OFFICE MEMORANDUM

Subject: Cracks in Retaining Wall on James Couzens Extension of Lodge Expressway. Research Project 61 F-63. Report No. 374.

Figure 1. Proposed 200-ft Trial Wall Section

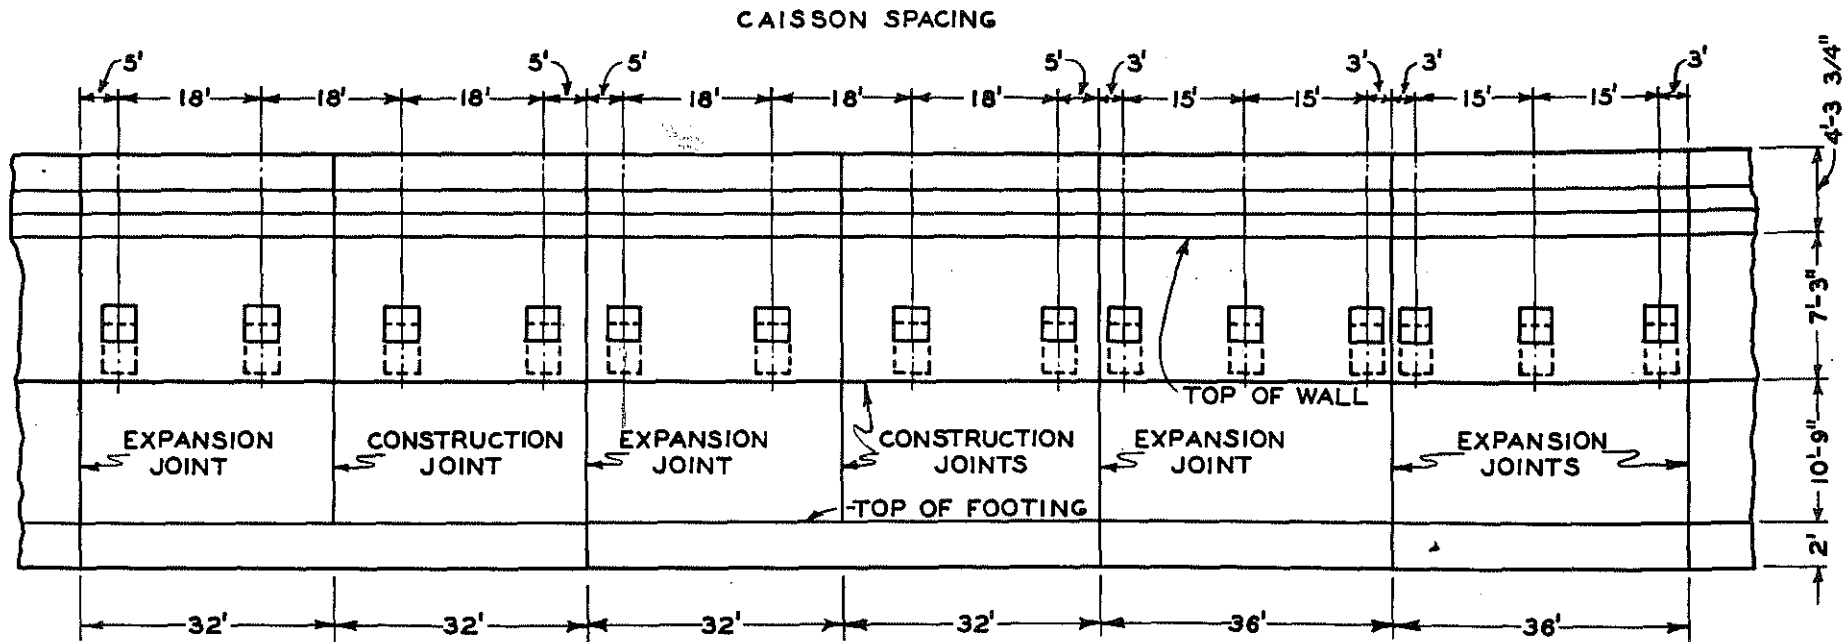
We agree with the recommendation for a trial wall section with a reduced expansion joint spacing. Of course, any change in the expansion joint spacing would necessitate a change in the caisson spacing. In line with our previous suggestion of reducing expansion joint spacing to 65 ft, Fig. 1 shows a proposed 200-ft trial section of a Type A-20 wall with expansion joints spaced at 64 and 36 ft. All wall details with the exception of the construction joint, expansion joint, and caisson spacing, and appropriate re-steel length and splice modifications to accommodate these spacings, would be the same as shown on the plans. As originally planned this wall type had expansion joints every 100 ft with construction joints spaced at 32 ft 9 in. and 34 ft 6 in. The caisson spacing was 18 ft, with a 5-ft edge distance between an expansion joint and the nearest caisson. This arrangement requires two more caissons than would have originally been utilized. We would also again suggest the increased steel percentage recommended in the August 15 report, as representing the minimum 0.25 percent as prescribed by the American Concrete Institute. Because we have not gone into the design quantitatively, the proposed caisson spacing or any similar trial wall section should be verified by the wall designers.

ALL WALL DETAILS ARE TO BE SHOWN ON THE PLANS WITH THE EXCEPTION OF THE JOINT AND CAISSON SPACING AND APPROPRIATE RE-STEEL LENGTH AND SPLICE MODIFICATIONS.
